Access Compliance Report Public Rights-of-Way (Curb Ramps)

Intersection ID: 44482 Main Street: AINSWORTH ST Cross Street: REDDING_GLEN_AV Location: NW ADA ID: C481B08B493E Ramp Type: Perp Initial Pass/Fail: Fail **Overall Compliance: No Severity Score:** 12.5

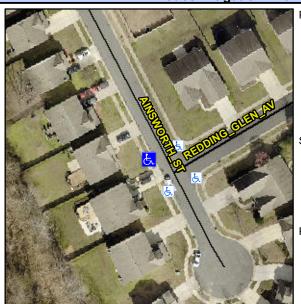
AINSWORTH ST Street 1 Name Stop Condition-Street 2 None Street 2 Name N/A Stop Condition-Street 1 N/A Possible Solutions: Remove & Replace Entire Ramp. Surveyor Notes: N/A PROW/ADA: Not Found, R304.5.3

Field Measurements/Component Compliance						
Compliance Description		Data	Comp	liance	Description	Data
N/A	Ramp Length (in)	47.5	Yes	Ramp	Slope (%)	5.8
Yes	Ramp Width (in)	48.0	No	Ramp	XSlope (%)	6.0
N/A	Flare Type LT	N/A	N/A	Flare	Type RT	N/A
N/A	Flare Slope LT (%)	N/A	N/A	Flare	Slope RT (%)	N/A
N/A	Flare Traversable LT?	N/A	N/A	Flare	Traversable RT?	N/A
N/A	Landing Length (in)	N/A	N/A	DWS	Provided?	N/A
N/A	Landing Width (in)	N/A	N/A	DWS	Contrast?	N/A
N/A	Landing Slope (%)	N/A	N/A	DWS	Length (in)	N/A
N/A	Landing X Slope (%)	N/A	N/A	DWS	Full Width?	N/A
N/A	Landing Curb? (Y/N)	N/A	N/A	DWS	Offset (in)	N/A
N/A	Shared Landing?	N/A				
N/A	Gutter Ponding?	N/A	N/A	Gutte	er Slope (%)	N/A
N/A	Gutter Lip Ht (in)	N/A	N/A	Gutte	r X Slope (%)	N/A
N/A	Painted X Walk1?	No	N/A	Paint	ed X Walk2?	N/A
	X Walk 1 Direction	To E		X Wa	lk 2 Direction	N/A
N/A	X Walk 1 Width (in)	N/A	N/A	X Wa	lk 2 Width (in)	N/A
	X Walk 1 Slope (%)	2.6		X Wa	lk 2 Slope (%)	N/A

X Walk 1 X Slope (%)	4.5		X Wa	lk 2 X Slope (%)	N/A
N/A	Ramp inside XWalk1?	N/A	N/A	Ramp	inside XWalk2?	N/A
	Road Slope (%)	N/A	N/A	Clear	Space?	N/A
	Road X Slope (%)	N/A	N/A	Clear	Space to XWalk (in)	N/A
N/A	Any Obstructions?	N/A	N/A	Storm	n Grate/Utility Hazard?	N/A
	Obstruction Type			Storm	n Grate/Utility Type	
		N/A				N/A
			Yes	Surfa	ce Condition? (G/P)	Good
